| No.      | Date | Description | By  |
|----------|------|-------------|-----|
| 10/08/20 |      | ADDENDUM 5  | RML |

**UNION STATION TRANSPORTATION CENTER ROOFING REPAIR/REPLACEMENT**  
 1 UNION PLACE, HARTFORD, CT

**SITE PLAN**

1 SITE PLAN

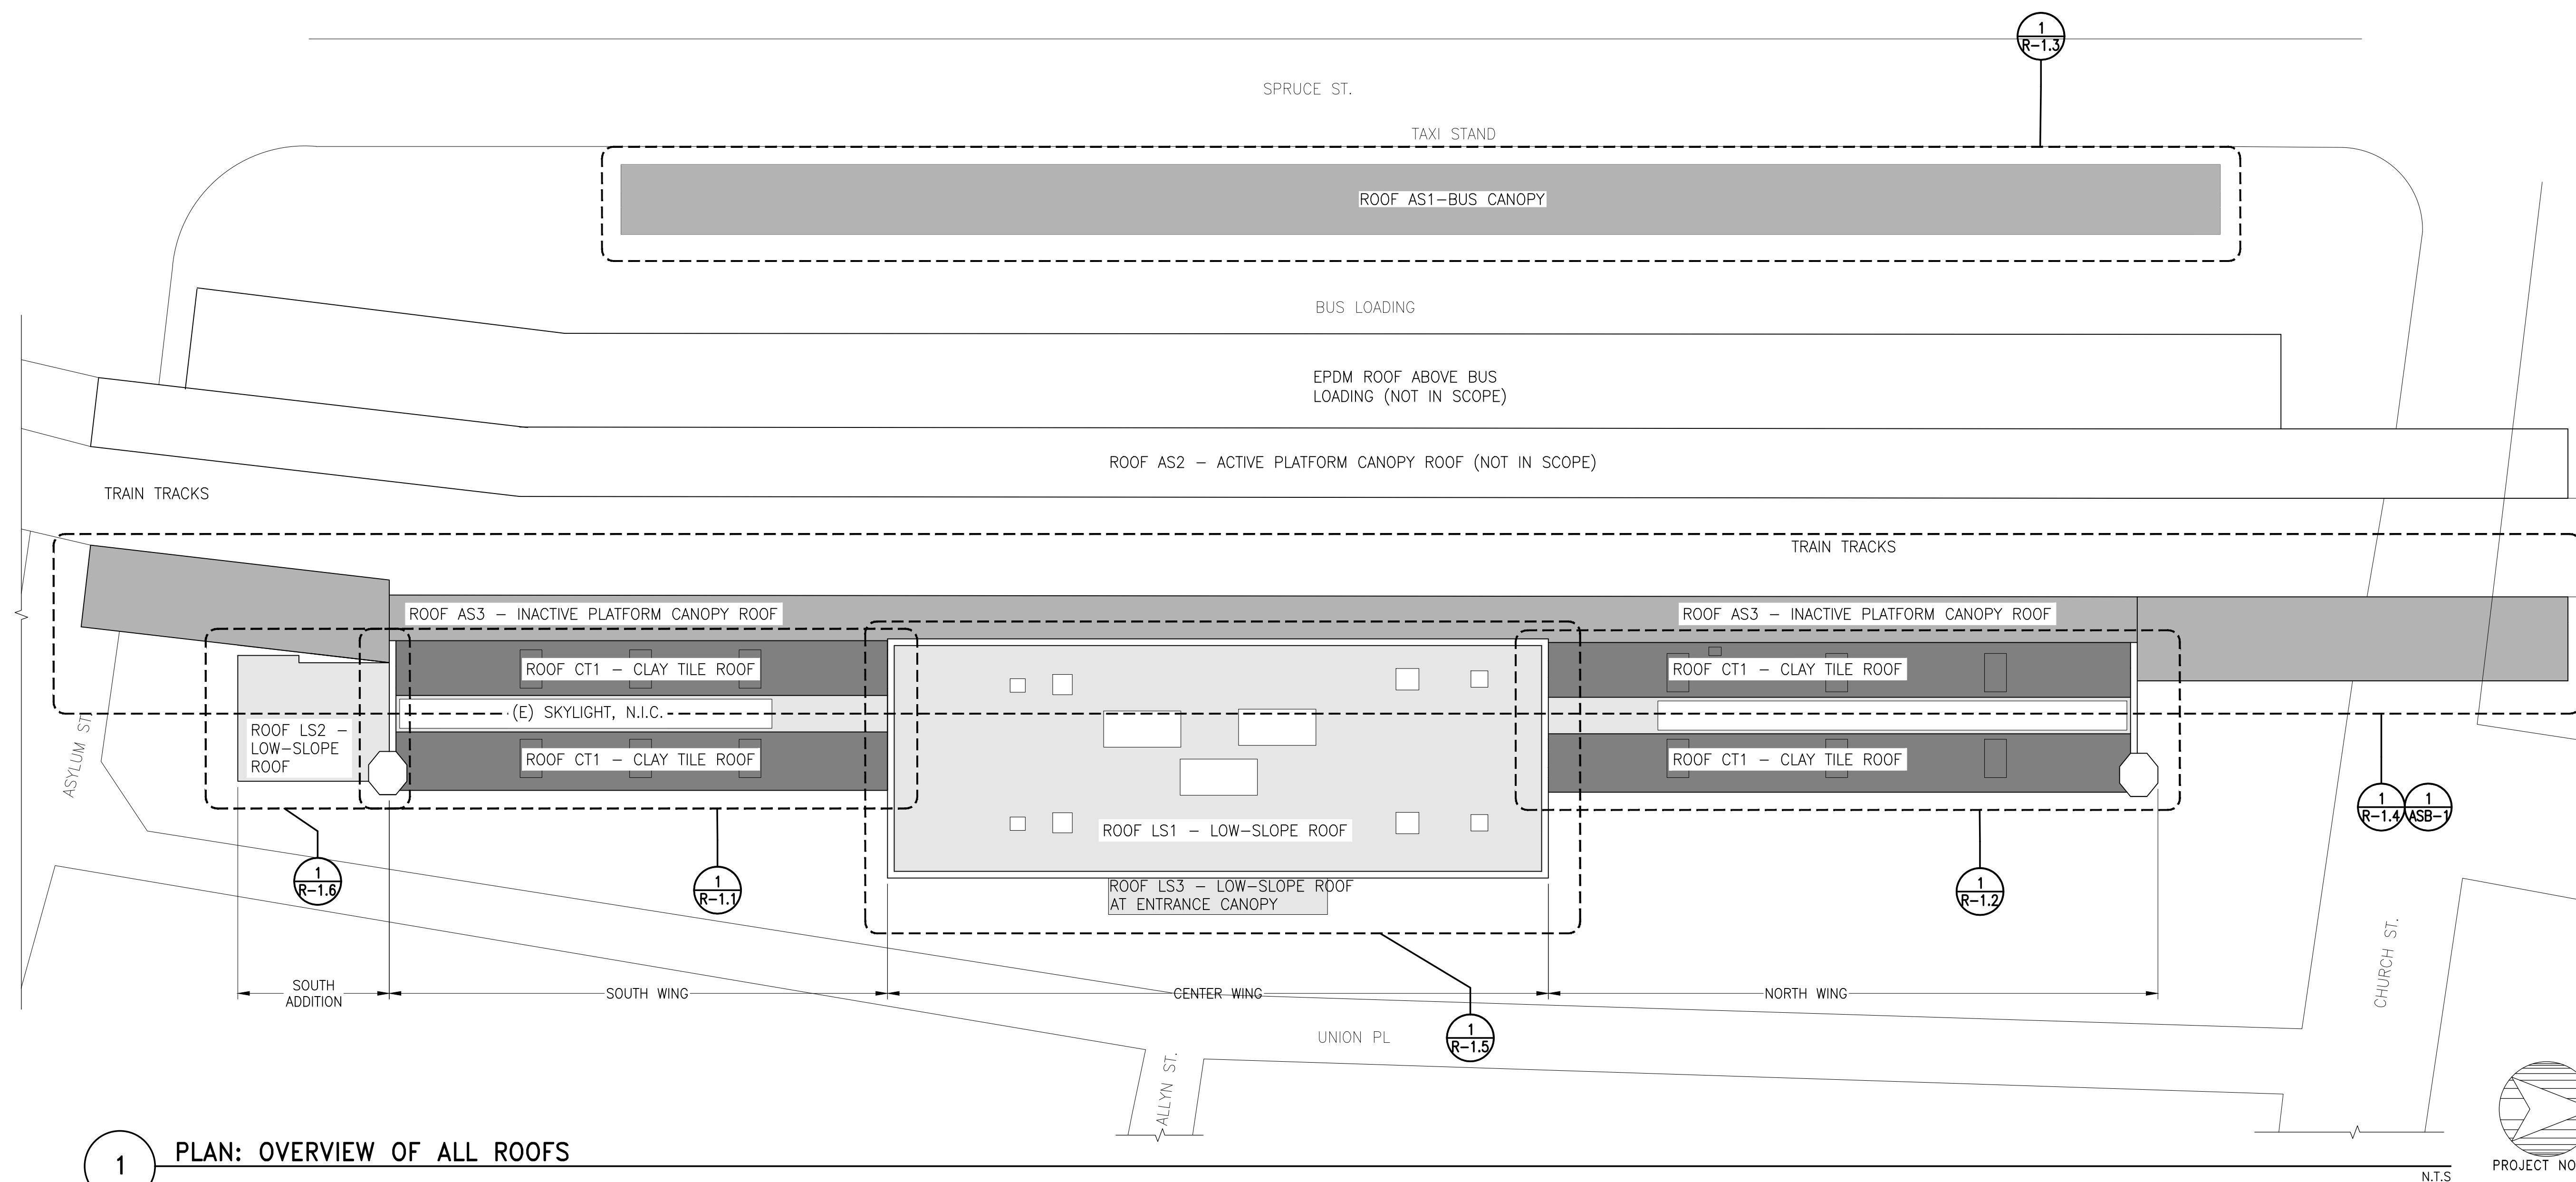
8. Assume no Contractor parking provided by owner.
9. ~~Businesses within the building will remain open throughout construction. Access to and from the building must be unobstructed at all times.~~

10. Proposed laydown area is at grade, beneath platform.
11. Proposed laydown area is on-grade beneath the Bus Canopy Roof (not on the Canopy Roof).
12. Proposed location of storage trailer beneath tracks.
